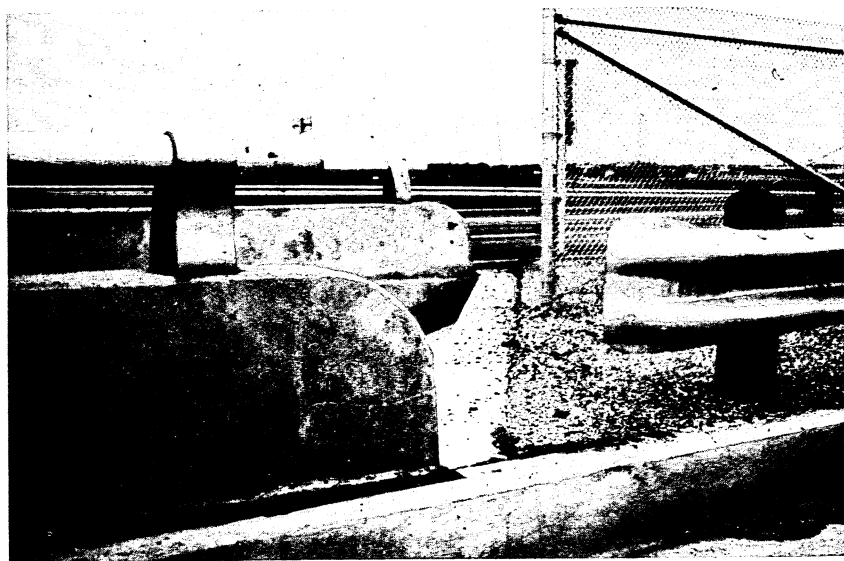
This is a half- or five-eighth-inch bolt, simply run through the concrete at one point. This is what you start to get, cracking developing, and some of these have pulled loose. Certainly it could not stand very much impact.

Mr. SKEELS My reaction was that they tried to do something but the solution is inadequate. To this—the size of this single bolt is wholly inadequate to develop the strength available in the guardrail. The tensile strength.

It is rather interesting on this same structure, that six of the eight possible points of contact of rail and structure have been fastened in the manner that we were just looking at in the previous slide. But two of them have not; on this side here is a place that is fastened and on this side it is not.

You see here they have even drilled—I do not know that you can make it out but there are two holes through here, Mr. Skeels; maybe they intended to put two bolts through there and for some reason did not put a second one through. I think there is only one place you can put a bolt through, anyway.
